# The View DC2 Rezoning Bylaw 19421

## What's Changed

## **Proposed Parkade Ramp Relocation**

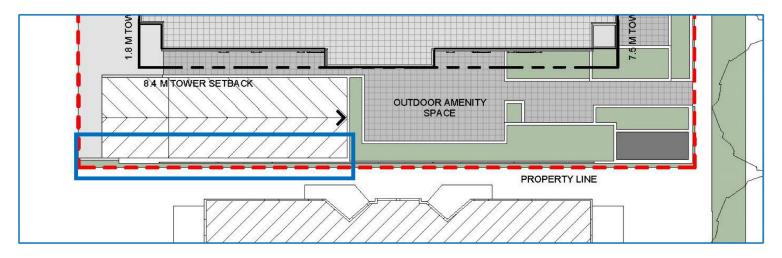
Improve safety and functionality of the underground parkade

Shift at grade parkade entry ramp 1.4 m to the south

## Swept Path Analysis

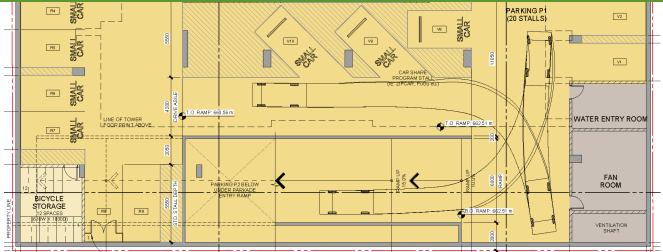
CURRENT RAMP LOCATION: VEHICLE APPROACH

PROPOSED RAMP LOCATION: VEHICLE APPROACH
